**ADDENDUM NO. 4**

**CHELSEA**

**Construction of the Silverline Gateway Busway,  
BRT Stations and Bridge Replacement (Steel) Br. No. C-09-001  
Washington Avenue over the MBTA Railroad**

**RESPONSE TO CONTRACTOR QUESTIONS**

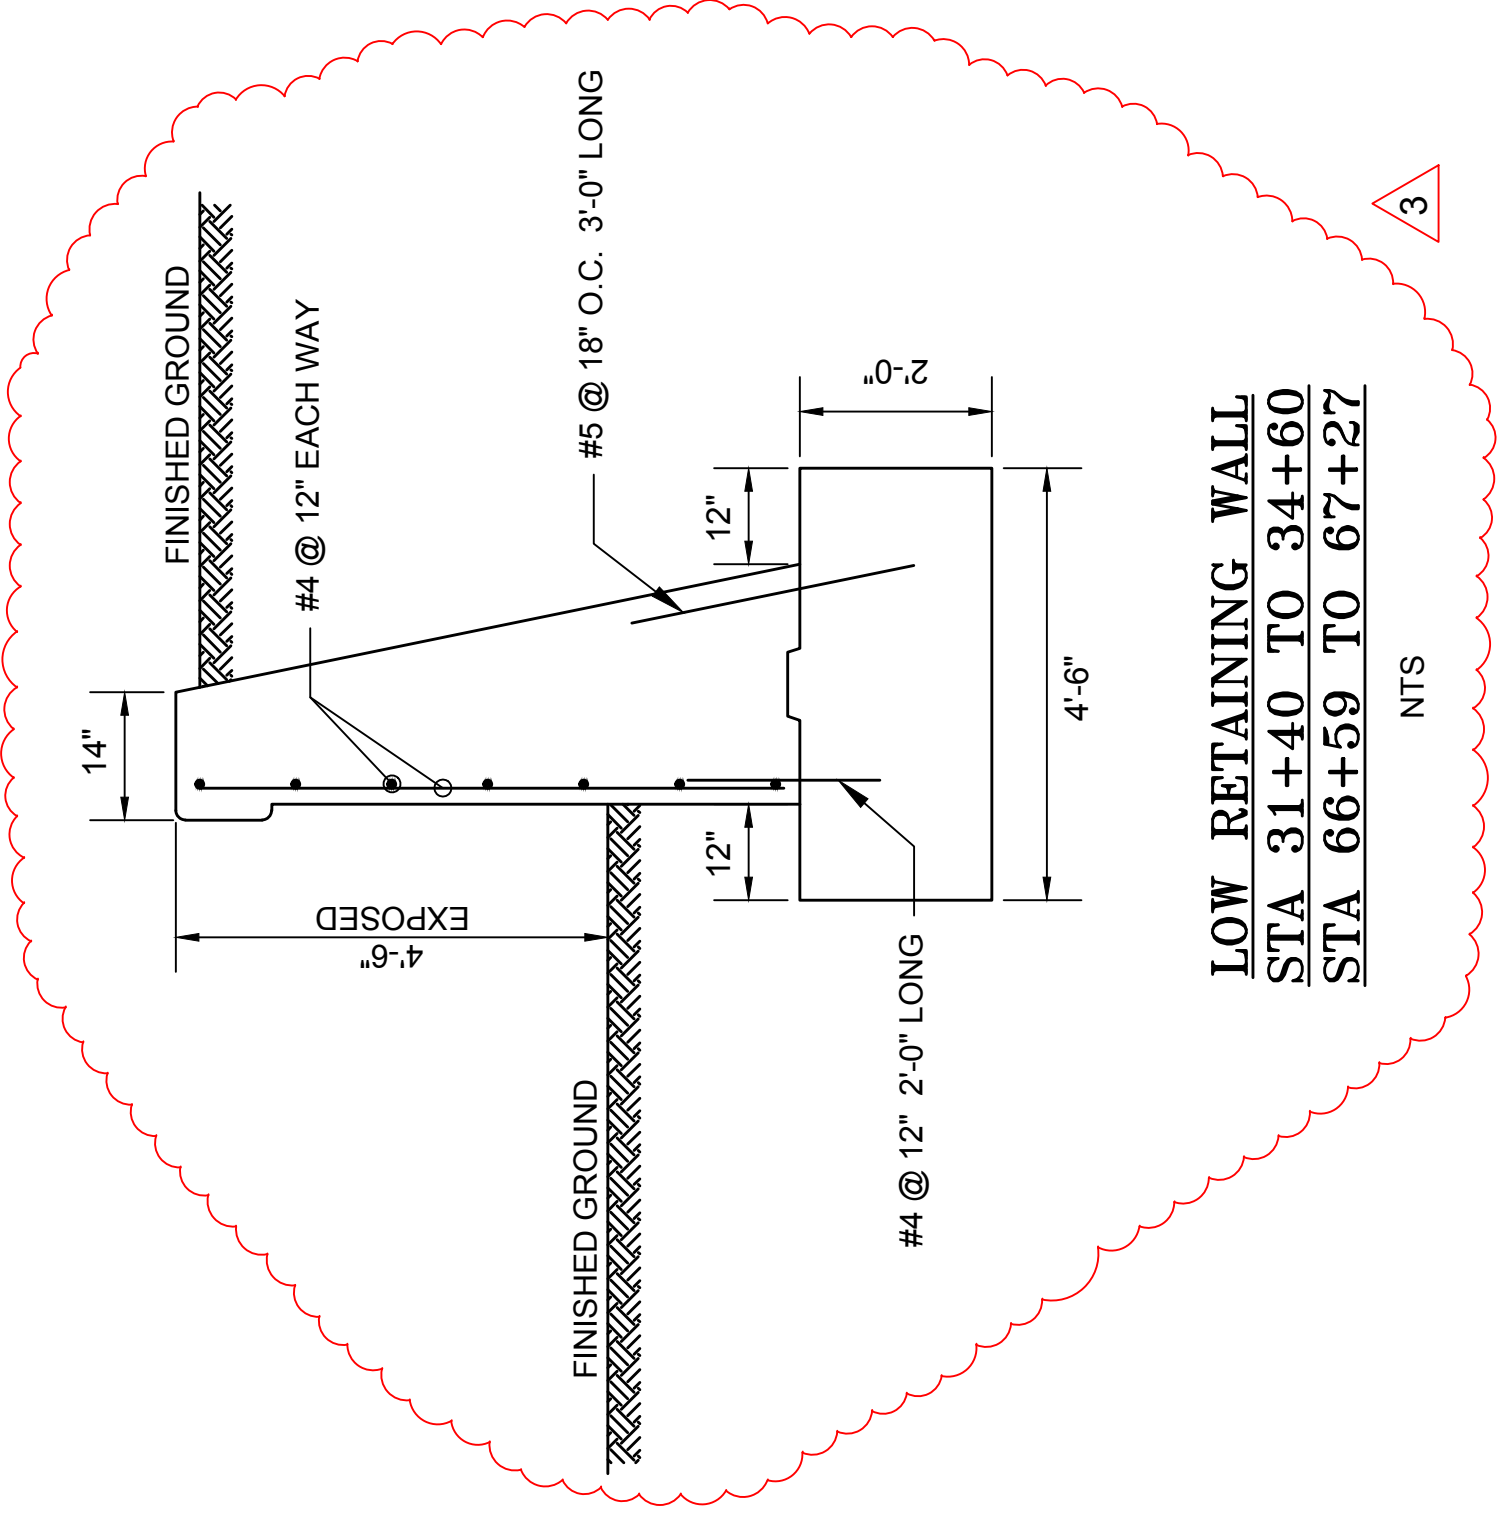
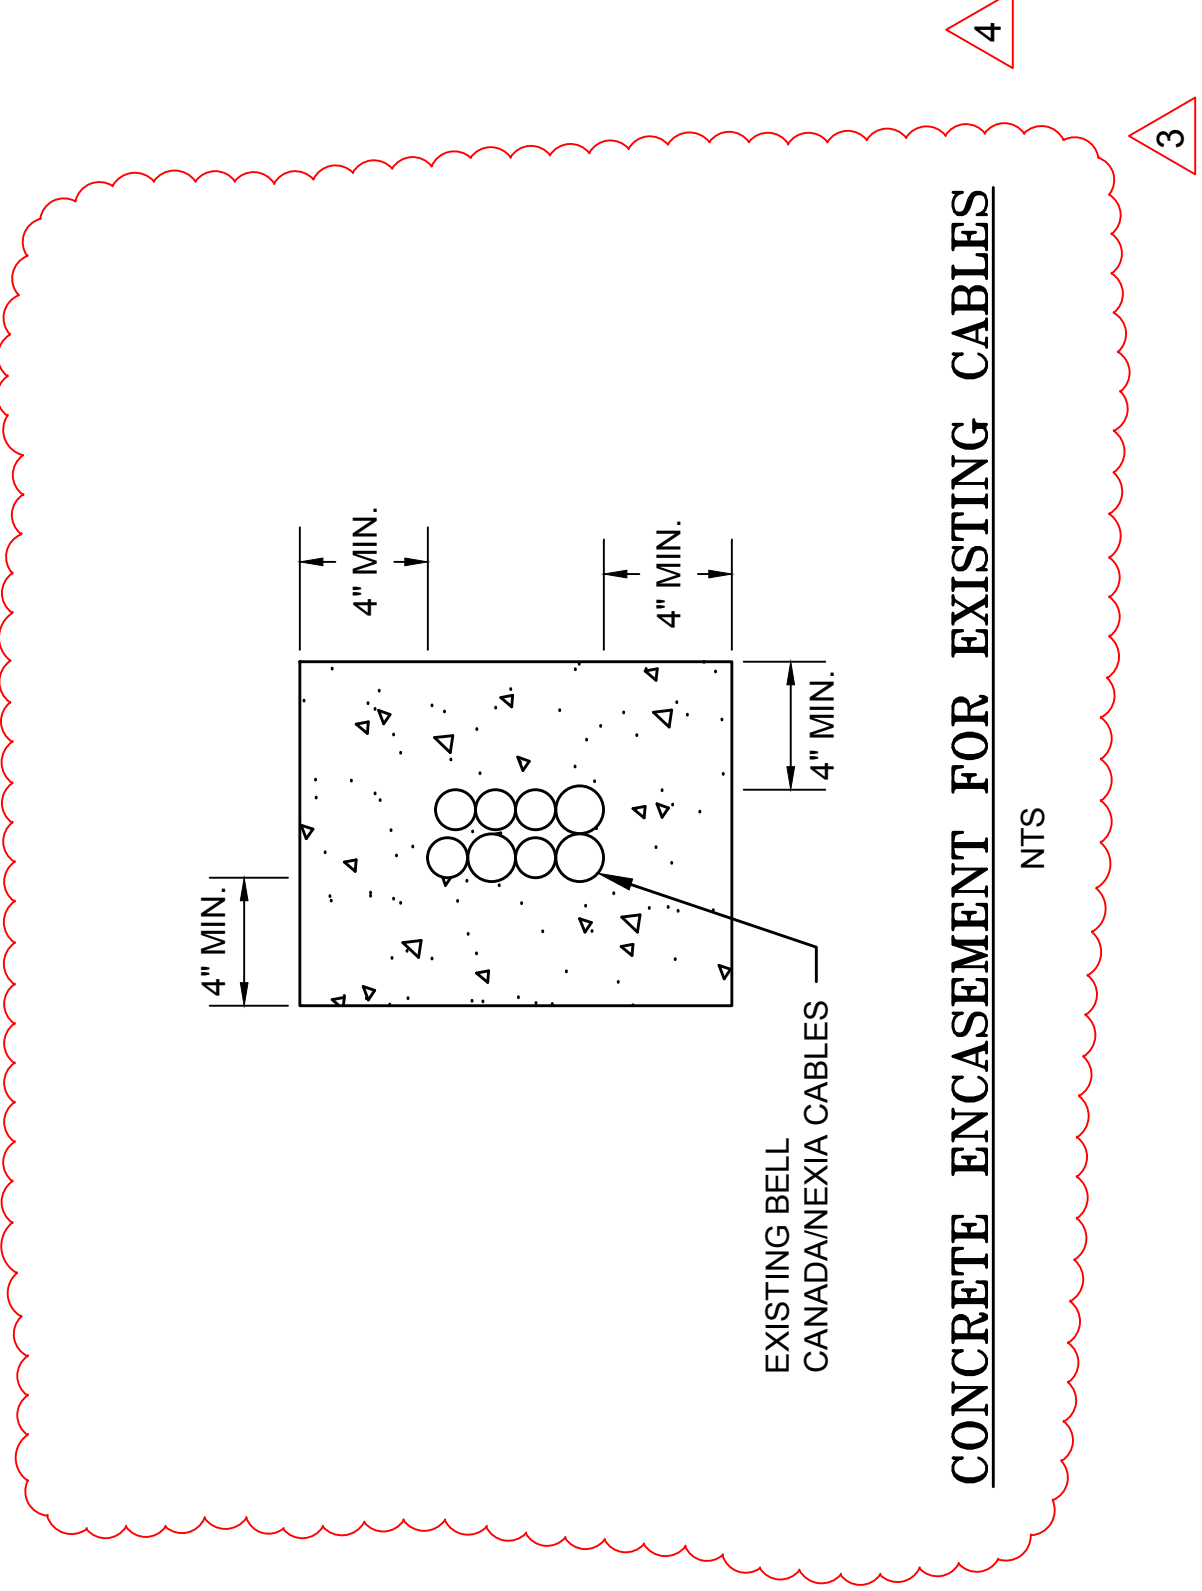
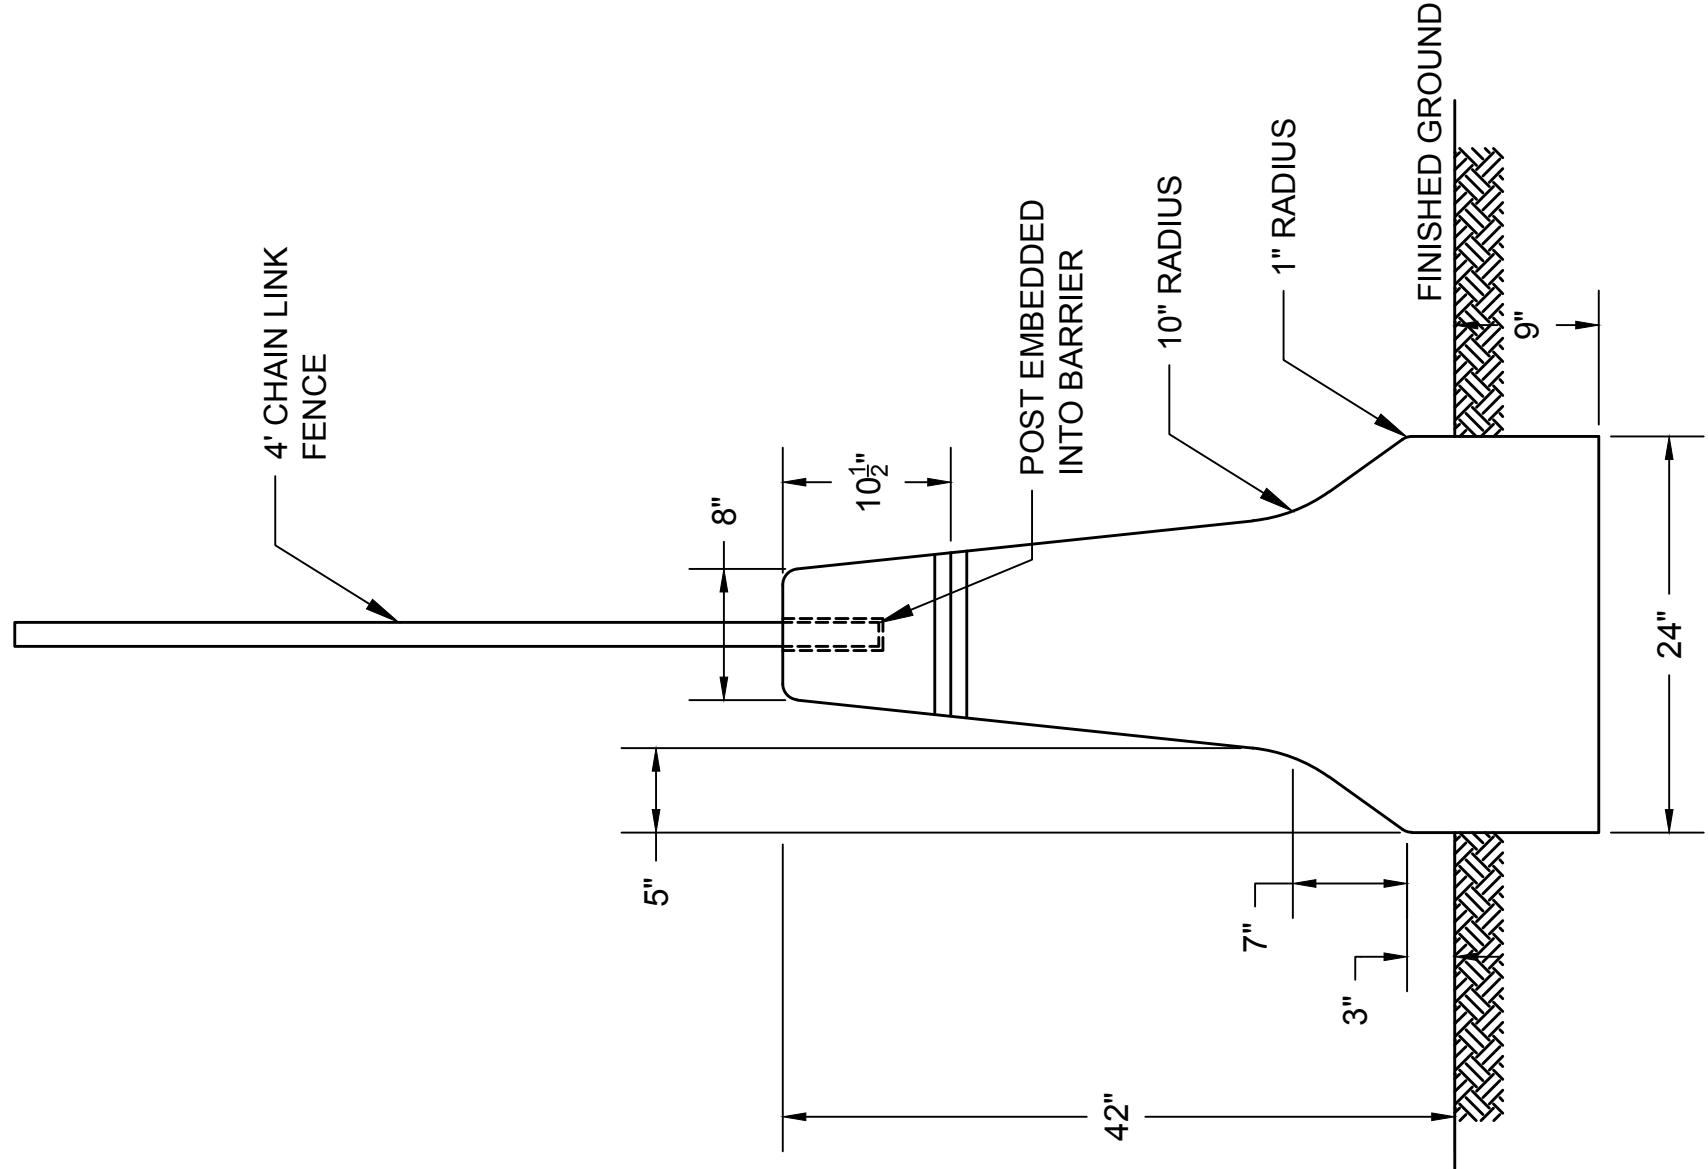
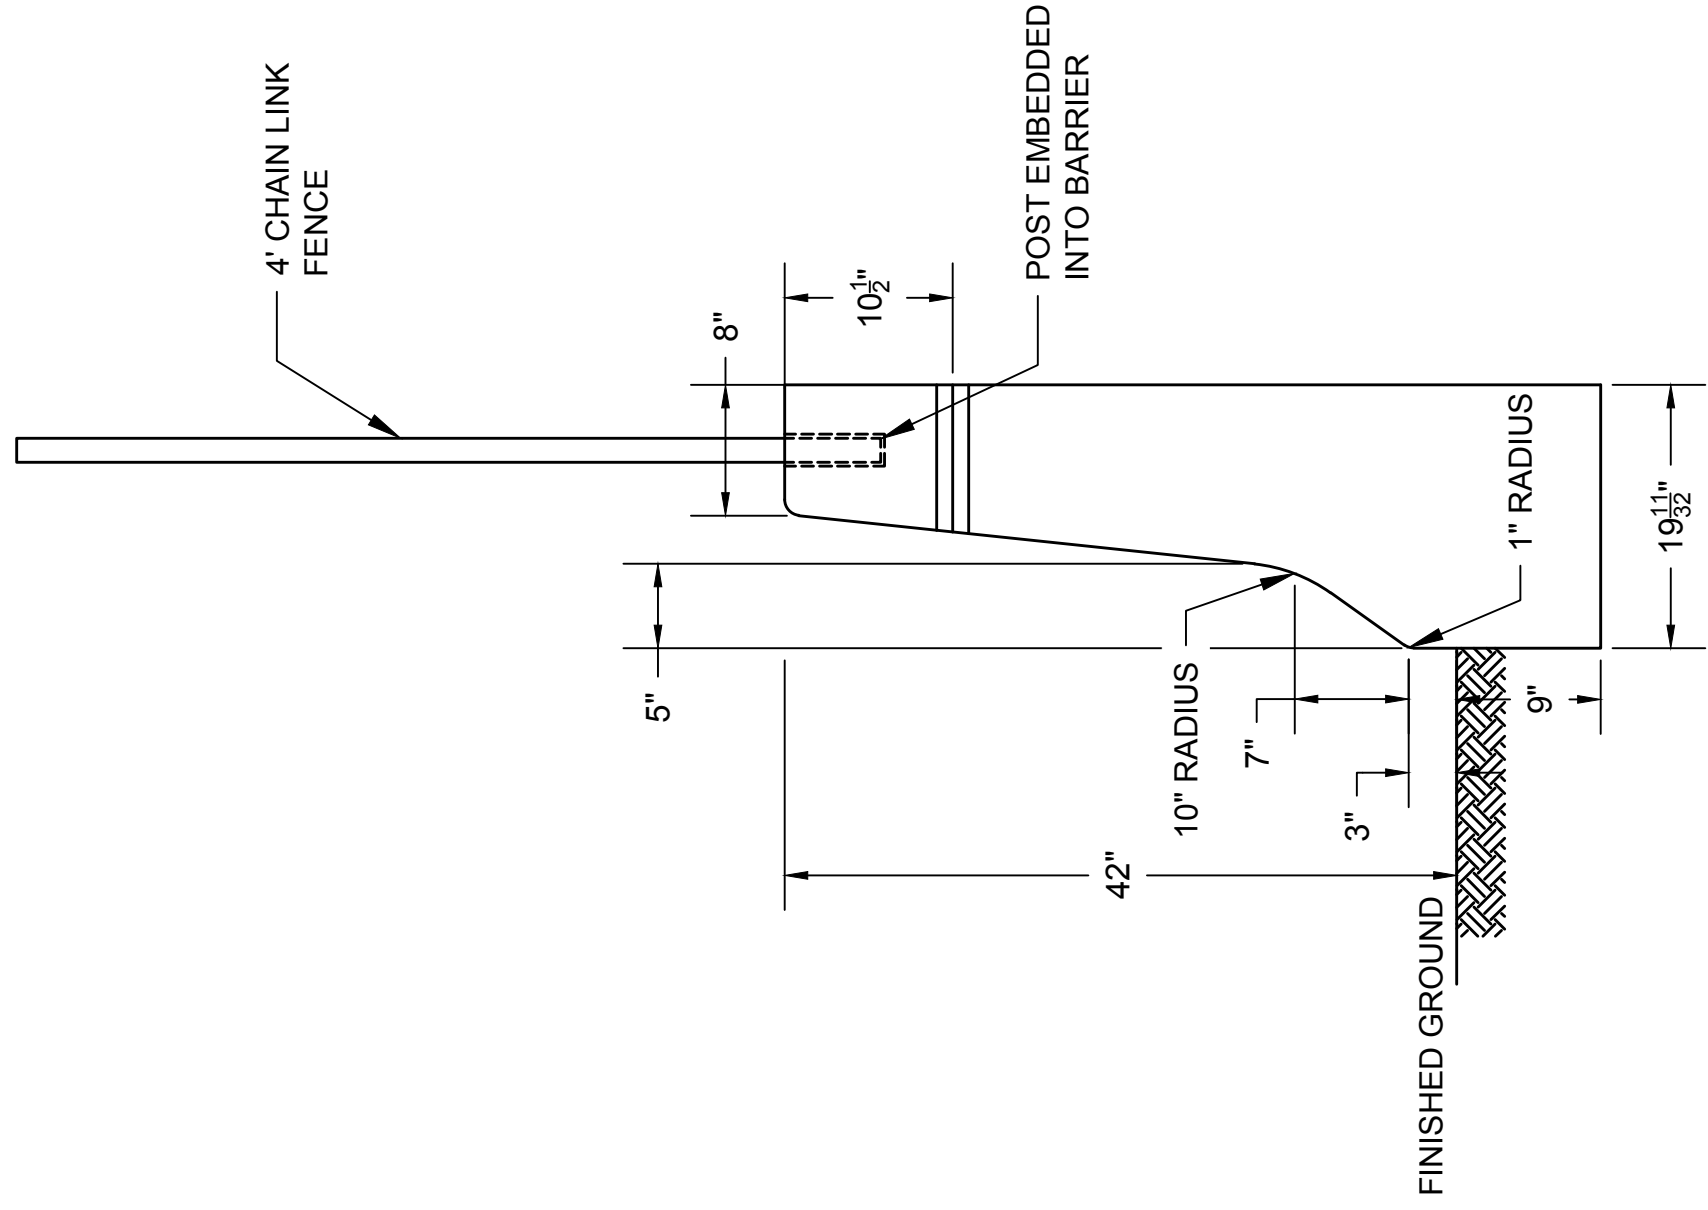
**Question 84)** Regarding 810.11, the detail on revised sheet 15 appears to indicate an existing sleeve surrounding the BellCanada ducts. Please confirm if this is the case, and what is the casing material?

**Question 87)** Under which bid item will the reinforcement for the low retaining walls (detail shown in Addendum #3, sheet 15) be placed under?

**Response 84)** There is no sleeve around the Bell Canada ducts. The detail on sheet 15 has been revised as part of this Addendum No. 4 to clarify.

**Response 87)** The steel reinforcement will be incidental to the cost of the low retaining walls and included in the Contract Unit Price for Item 901.
